REMARKS

Claims 1-24 and 38-50 are pending in the application, claims 25-37 being canceled and claims 39-50 being newly added herein. Claims 1, 38, 39, and 47 are the only independent claims.

FIG. 3

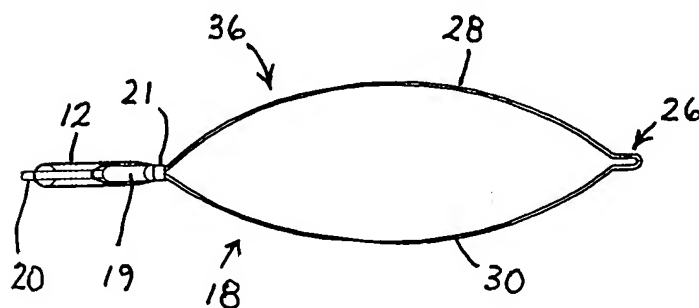
The drawings were objected to as failing to comply with 37 C.F.R. 1.84(p)(5) because they do not include the following reference signs mentioned in the description: reference numeral 21, page 8, line 12; reference numeral 16, page 9, line 1.

In partial response to the objection to the drawings, applicant encloses herewith a replacement sheet for Figures 2 and 3, showing the reference numeral 21 in both those figures. Also enclosed is an annotated copy of that sheet of drawings, showing the addition of the reference numeral in red ink.
